Service Information Bulletin

SUBJECT	DATE
Check for Rough Running or Stalling - Three-Filter Fuel System	February 2014

Publication Number / Title	Platform	Section Title	Change
DDC-SVC-MAN-0084	DD Platform	Check for Rough Running or Stalling - Three-Filter Fuel System	Added steps 1 through 8a. Added graphics for step 12.

d470309

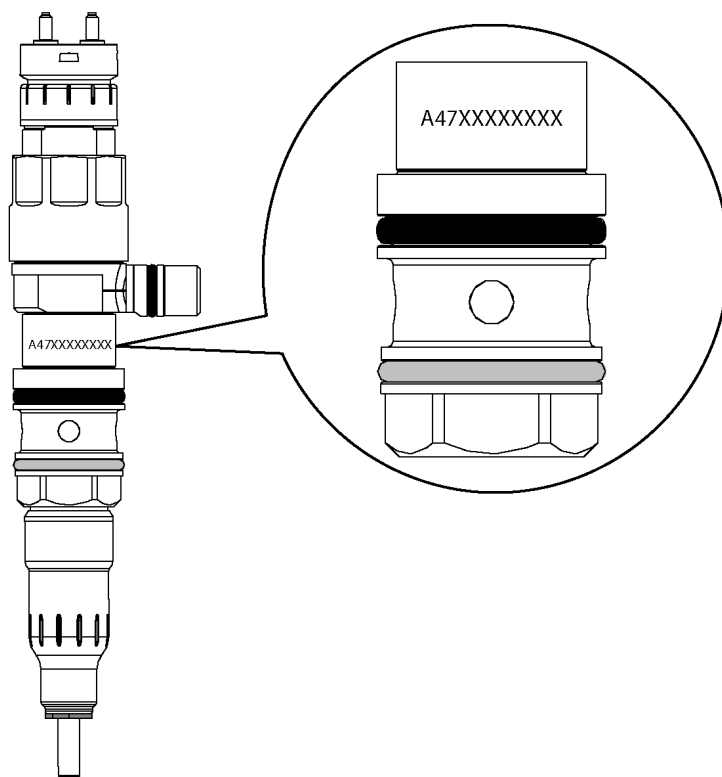
11. Remove prefilter, coalescer and final filters. Check for damaged or missing seals on the bottom of the filters. Are there damaged or missing seals at the bottom of the filters?
 - a. Yes; replace fuel filters as necessary.
 - b. No; Go to step 12.
12. Check air vents at the top of the Fuel Separator/Coalescer and final filter for blockage.

- a. If the Water Separator/Coalescer and final filters have blockage, replace the fuel filters as needed.
Refer to section "Removal of the Water Separator/Coalescer - Three-Filter System".
Refer to section "Removal of the Final Filter - Three-Filter System".
- b. If no blockage is found, Go to step 13.
